# Memorandum

**TO:** Columbia River Crossing Task Force  
**FROM:** CRC Pedestrian and Bicycle Advisory Committee (PBAC)  
**SUBJECT:** PBAC Recommendations for World Class Pedestrian and Bicycle Facilities

## **Purpose of this Memorandum**

# PBAC Proposed Pedestrian and Bicycle System for Replacement Bridge

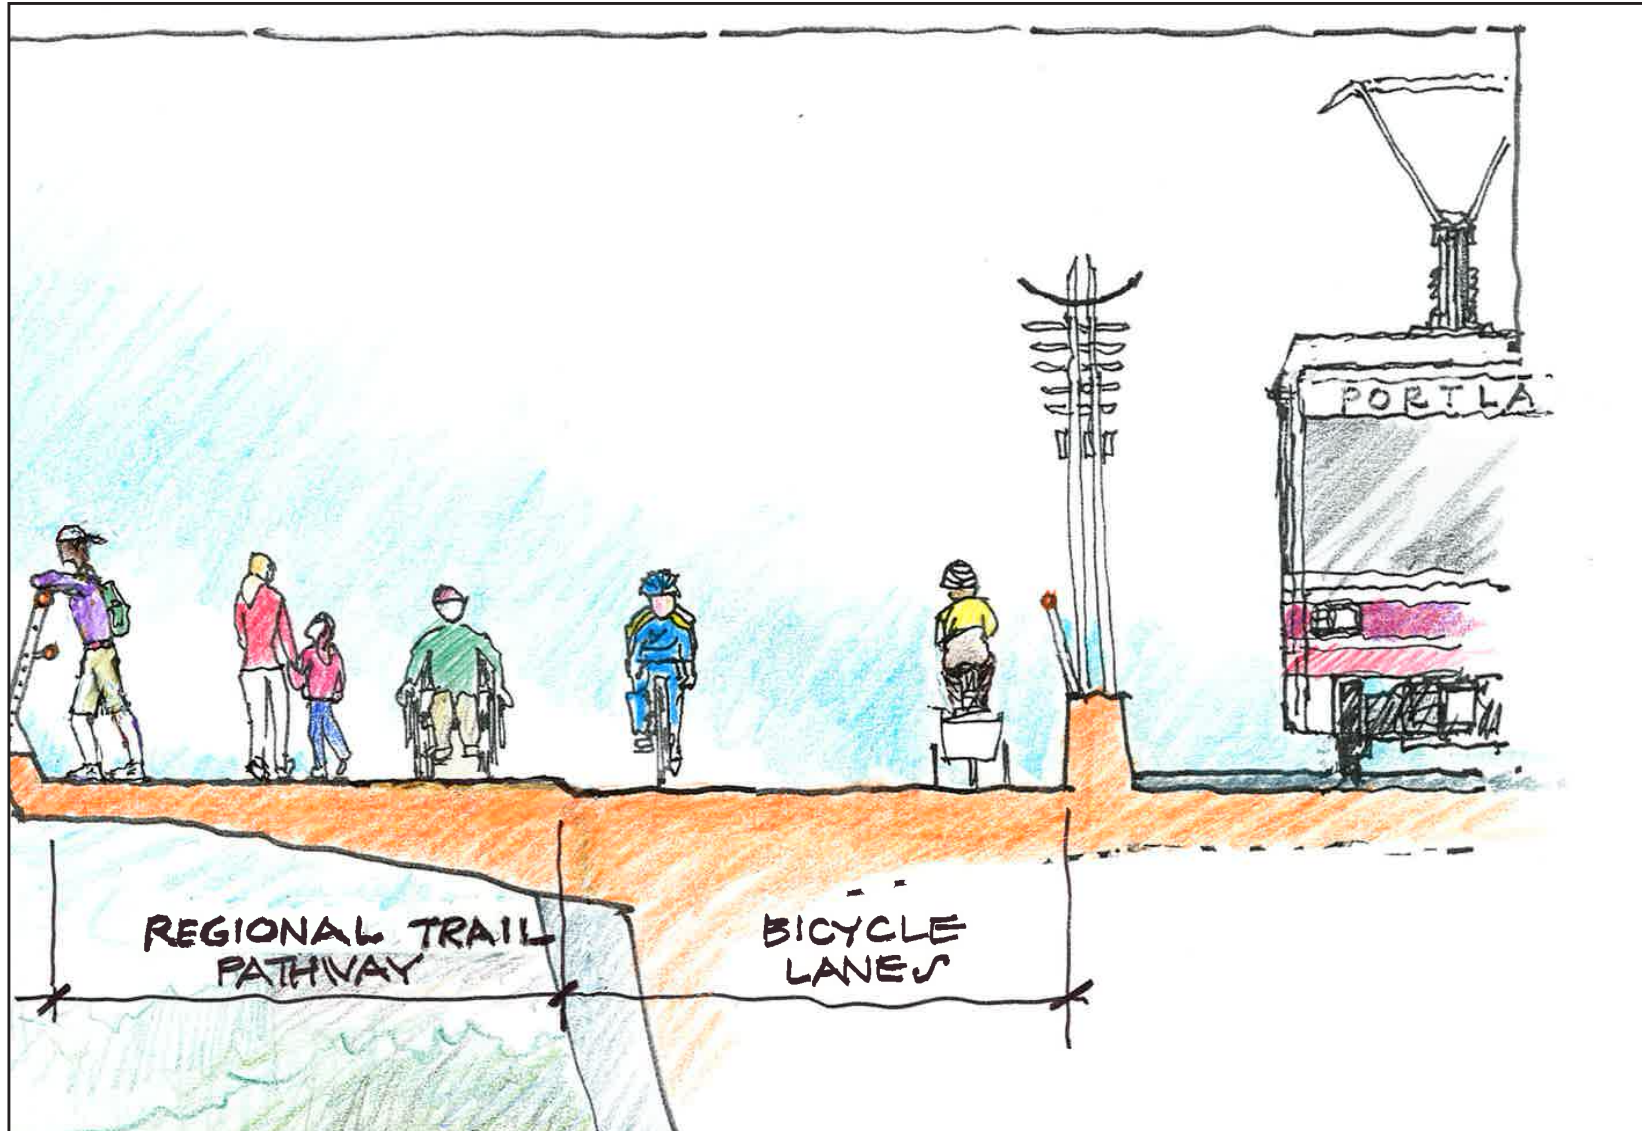
- The overall pathway on the western bridge (adjacent to the transit guideway) must provide separation between recreational users and higher speed bicycle users. To provide this separation, a 12-foot wide regional trail should be provided adjacent to, and to the west of, a pair of six-foot wide bicycle lanes (see attached rendering). These recommended widths are exclusive of potentially needed shy distances, i.e., free and clear of poles and other obstructions to enable safe pedestrian and bicycle movement (a summary of agency standards for multiuse paths, sidewalks and bike lanes is attached).

- In addition to the combined regional trail and bicycle lanes on the western bridge, an eight-foot wide sidewalk should be provided on the eastern bridge (the bridge that would serve the northbound traffic lanes) across both the Columbia River and the North Portland Harbor. The sidewalk across the North Portland Harbor would touch down on Hayden Island and use surface street sidewalks to connect to the sidewalk across the Columbia River.

While this facility would primarily serve pedestrians, accommodations should be provided for the occasional recreational bicyclist, e.g., wheel gutters (narrow ramps alongside stairs for rolling a bicycle while climbing stairs). It is understood that for physical and environmental reasons connecting this eastern sidewalk directly with the Vancouver shore would be challenging and most likely would require routing it westerly under the replacement bridge to tie in with the western multi-use pathway above the shore.

- Additional access points, discussed as possibilities in the Draft EIS, should be provided to make the river crossing paths connect more directly to parks and recreational trails. Some examples of these facilities are the Columbia River Waterfront Trail in Vancouver, the river adjacent areas on Hayden Island, and the 40 Mile Loop in Oregon.
- Viewpoints or "belvederes" should be provided at locations along both the regional trail on the western bridge and the sidewalk on the eastern bridge. These features would also function as rest areas for pathway users.
